INSPECTION REPORT
Sedimentation Structure
J7-K
Black Mesa Mine
Navajo County, Arizona

for
PEABODY COAL COMPANY

Dames & Moore
10139-011-22

SITE PLAN J7-K

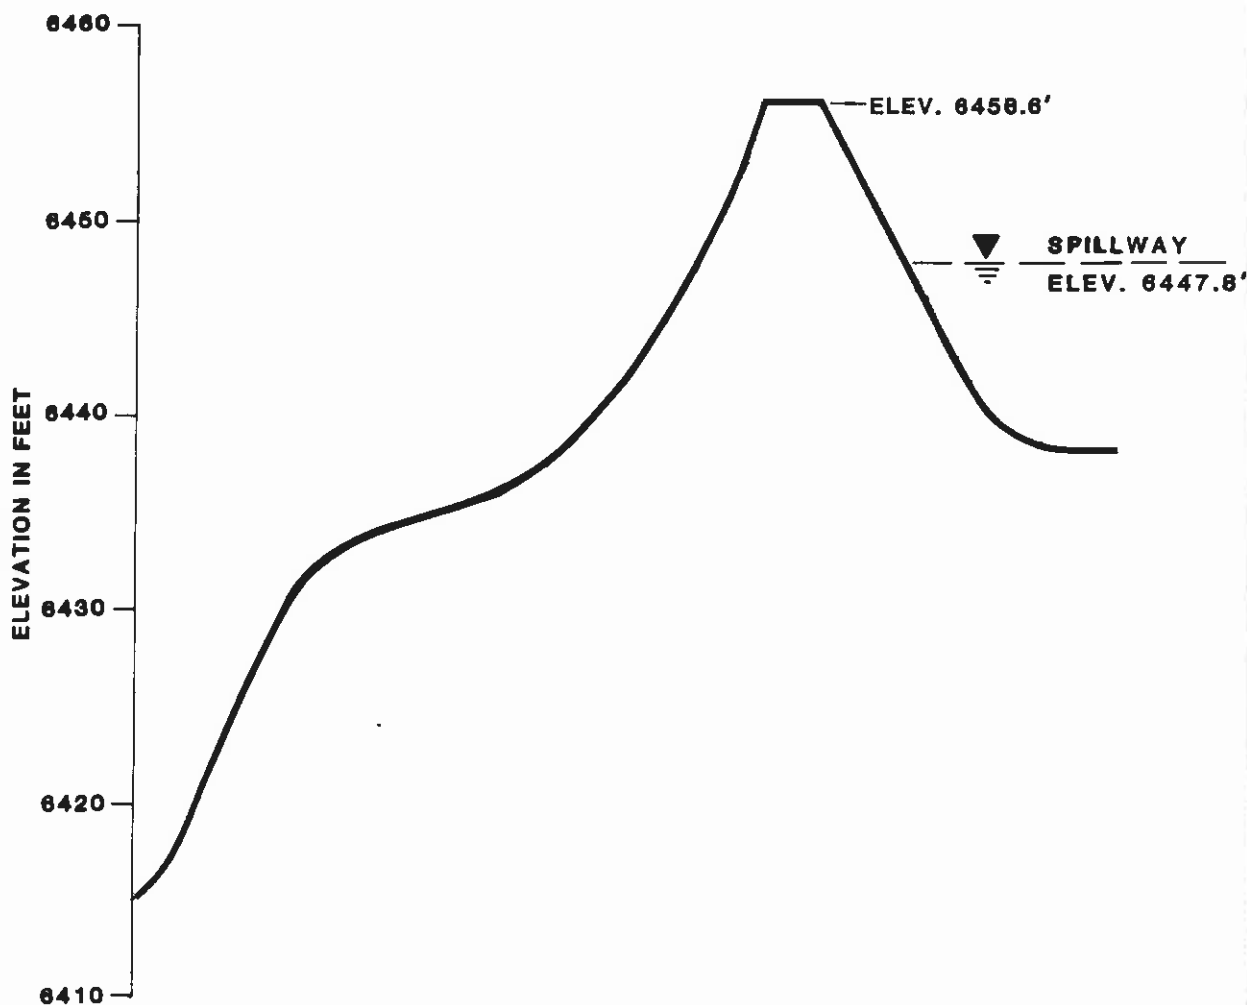
The storage capacity and spillway capacity of Structure J7-K are adequate; however, the spillway does not have an adequate outflow channel or adequate erosion protection. A trapezoidal outflow channel should be constructed along the alignment B-B' shown in Plate 1. The channel profile is shown in Plate 4 and the required dimensions are shown in Plate 5. Both the spillway and outflow channel should be protected against erosion using geotextile and riprap as shown in Plate 5.

EXISTING
MAXIMUM CROSS-SECTION
A-A'
J7-K

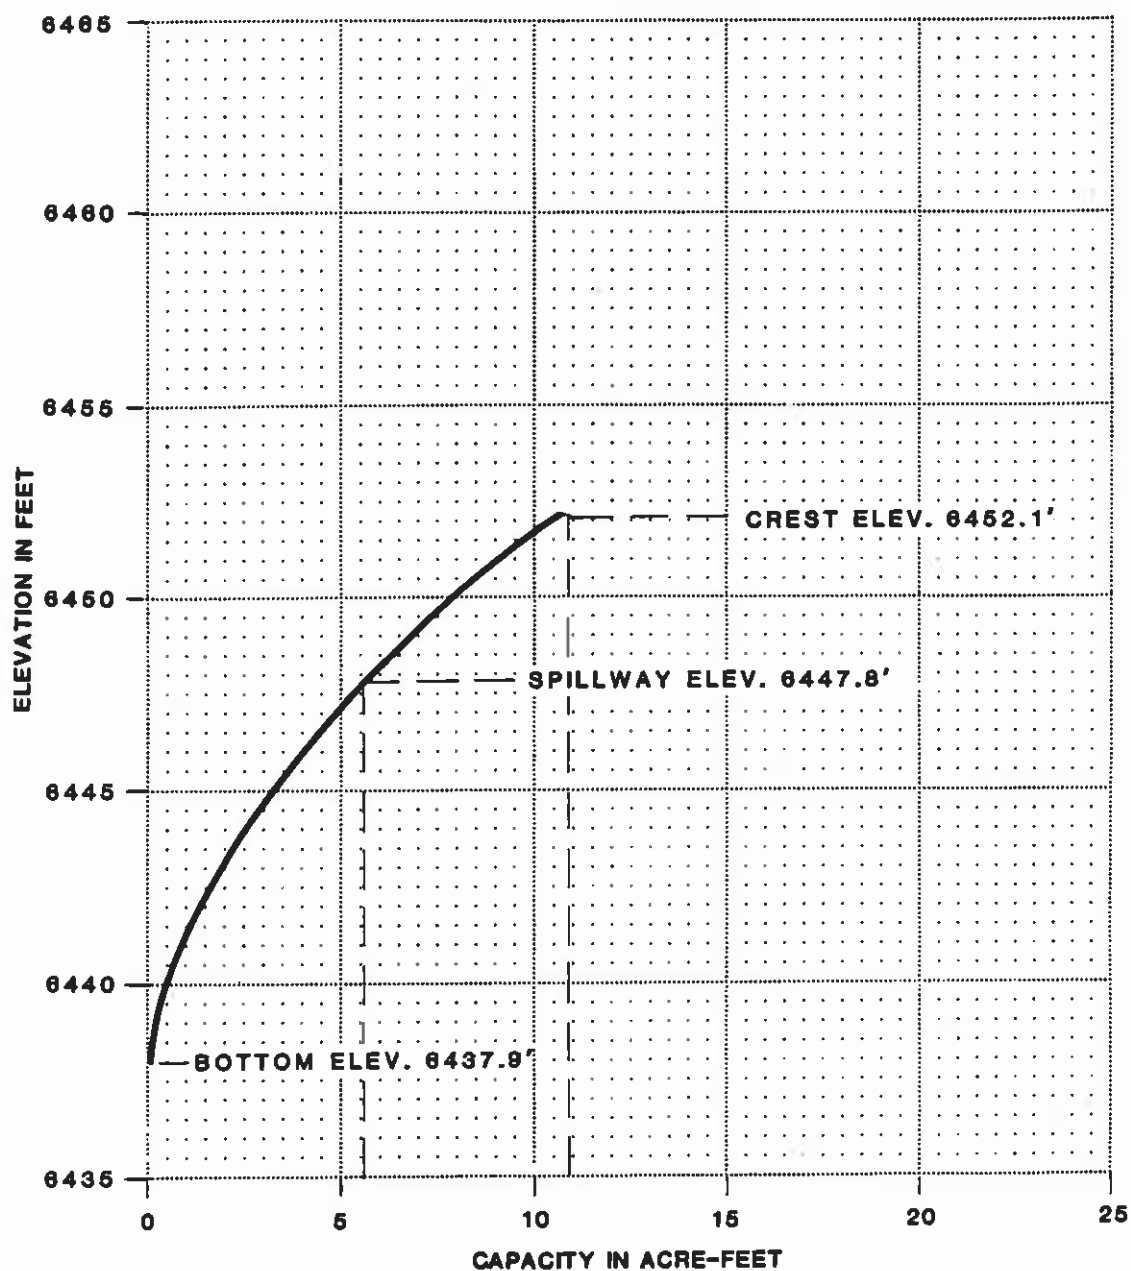
The inspection of Structure J7-K indicated that the geotechnical problems consist of rills on the upstream and downstream slopes, the side slopes of the spillway and outlet channel and the right and left abutments; and a steep downstream slope. Correction of erosion is considered a periodic maintenance task and does not require remedial action.

SPILLWAY AND OUTFLOW CHANNEL CROSS SECTION J7-K

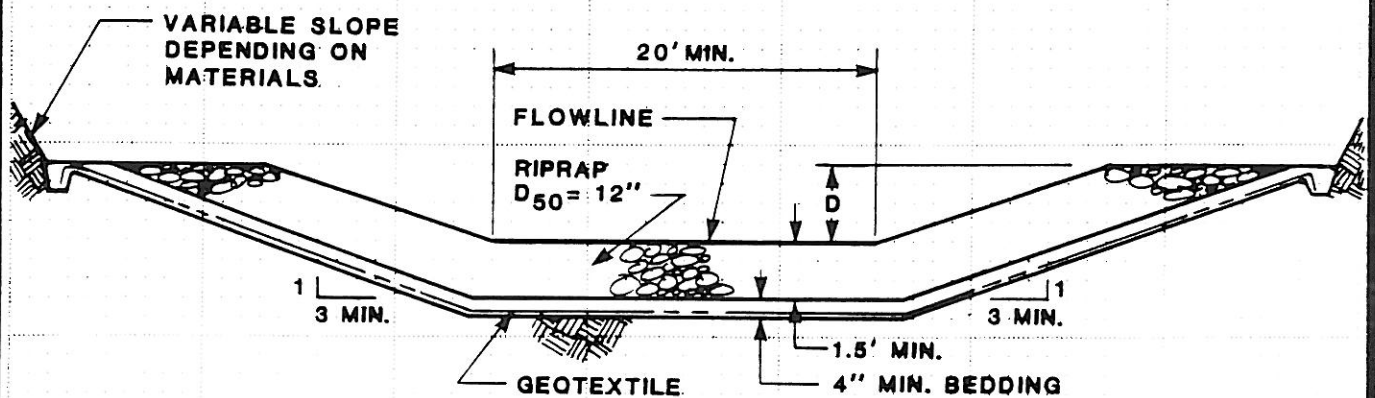
There is presently no erosion protection within the channel.

There is presently no erosion protection within the channel.

SPILLWAY CHANNEL

D = 2.3'

LENGTH = 50'

FLOWLINE ELEV. = 6447.80'

OUTFLOW CHANNEL

D = 1.5'
